SB-GA8-2005-25

# **Service Bulletin**

Remarking of	airspeed	indicator	white	and	green	arcs.

All GA8 aircraft up to serial number GA8-05-075.

Figure 1 -Airspeed indicator marking

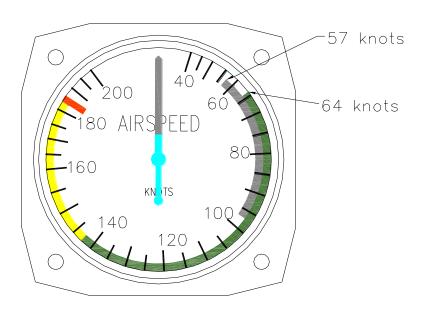
Additional flight testing of the GA8 to validate the calibration of the pitot-static system in slow speed flight near the stall has resulted in amended figures for indicated stall speeds. Accordingly the lower limits of the white and green arcs on the airspeed indicator (ASI) are required to be remarked. Note that the change of markings to the ASI has no affect on the stated indicated and calibrated airspeeds quoted in the Approved Flight Manual.

1. Remark the existing ASI (P/N GA8-341012-11) white arc to commence at 57 knots, and the green arc to commence at 64 knots. Refer to Figure 1. Re-identify the modified part as GA8-341012-15.
